Well Name: TODD 13G FEDERAL	Well Location: T23S / R31E / SEC 13 / SWNE /	County or Parish/State: EDDY / NM
Well Number: 21	Type of Well: OIL WELL	Allottee or Tribe Name:
Lease Number: NMNM0404441	Unit or CA Name:	Unit or CA Number:
US Well Number: 3001531514	Well Status: Oil Well Shut In	Operator: HARVARD PETROLEUM COMPANY LLC

Notice of Intent

Type of Action: Plug and Abandonment

**Permanent Abandonment of Federal Wells
Conditions of Approval (LPC Habitat)**

BLM Approved Plugs

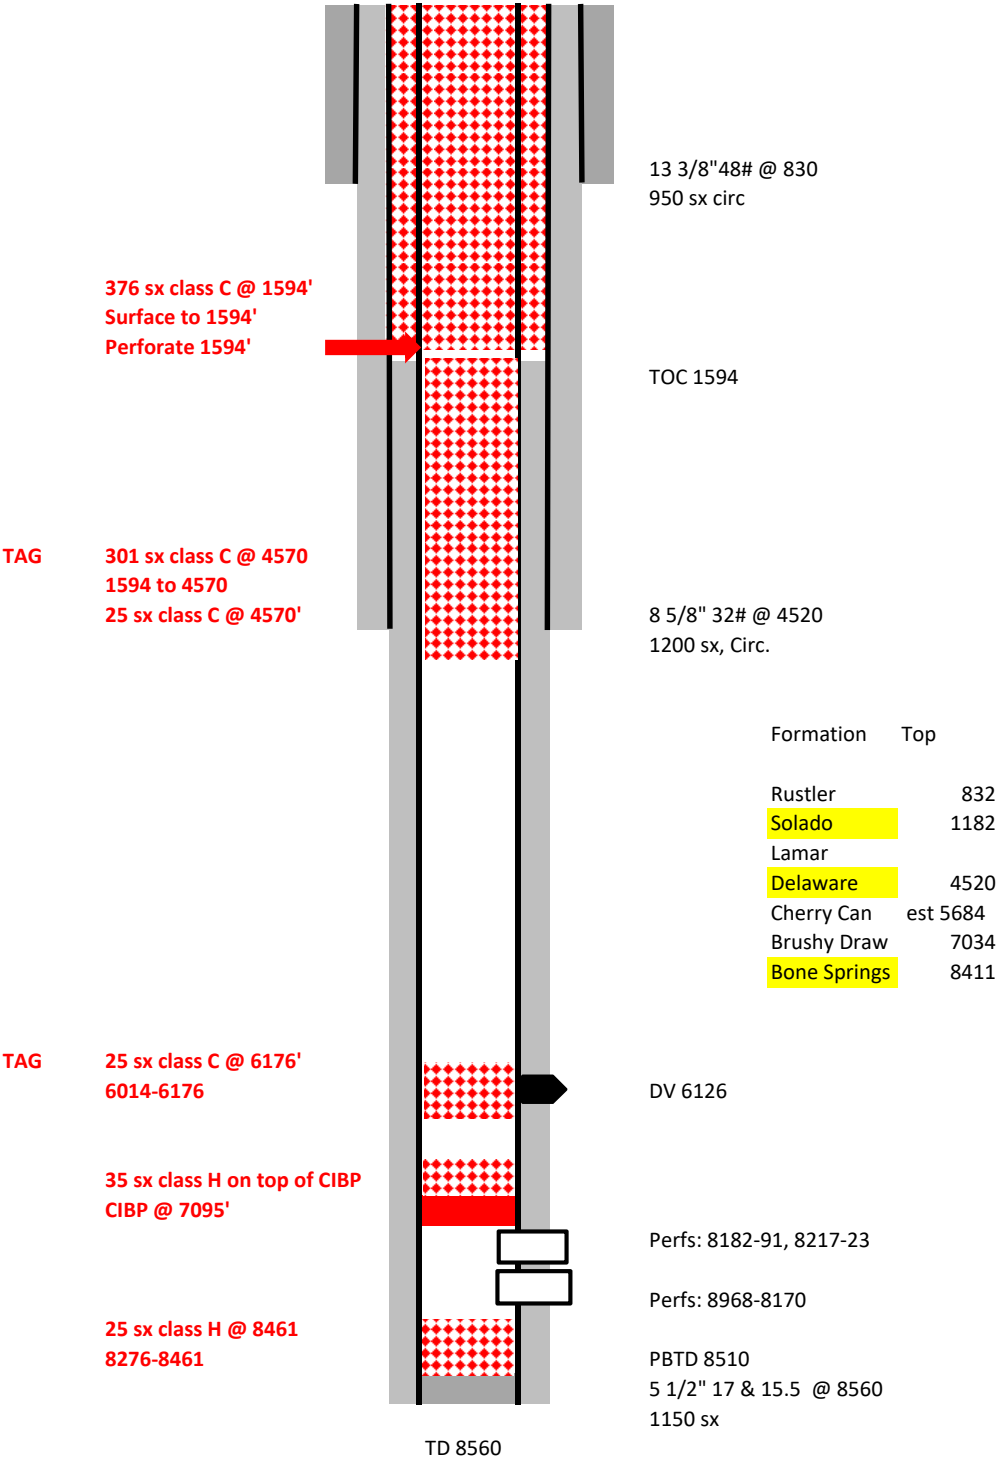
Sundry ID		2728522					
Plug Type	Top	Bottom	Length	Tag	Sacks	Cement Class	Notes
Surface Plug	0.00	100.00	100.00	Tag/Verify			
Shoe Plug	771.70	880.00	108.30	Tag/Verify			
Top of Salt @ 1182	1120.18	1232.00	111.82	Tag/Verify			
Base of Salt @ 4275	4182.25	4325.00	142.75	Tag/Verify	376.00	C	Perforate and squeeze from 1594' to surface. (In 162 sxs/Out 214 sxs) Verify at surface.
Shoe Plug	4424.80	4570.00	145.20	Tag/Verify			
Delaware @ 4520	4424.80	4570.00	145.20	If solid base no need to Tag (CIBP present and/or Mechanical Integrity Test), If Perf & Sqz then Tag, Leak Test all CIBP if no Open Perforations	301.00	C	Spot cement from 4570' to 1594'. WOC and Tag.
DV tool plug	6014.74	6176.00	161.26	Tag/Verify	25.00	C	Spot cement from 6176' to 6014'. WOC and Tag.
CIBP Plug	7060.00	7095.00	35.00	If solid base no need to Tag (CIBP present and/or Mechanical Integrity Test), If Perf & Sqz then Tag, Leak Test all CIBP if no Open Perforations	5.00	H	Set CIBP at 7095'. Dump bail 35' on top. Leak Test CIBP.

If solid base no need to Tag (CIBP present and/or Mechanic al Integrity Test), If Perf & Sqz then Tag, Leak Test all CIBP if no Open Perforatio ns			
Bonesprings @ 8411	8276.89	8461.00	184.11		25.00	H	Tag PBTD and spot cement from 8461' to 8276'. WOC and Tag.
Shoe Plug	8424.40	8610.00	185.60	Tag/Verify

Created By	Condition	Condition Date
gcordero	Spot 25 sacks cement 5488' - 5258' - T Cherry Canyon	11/2/2023
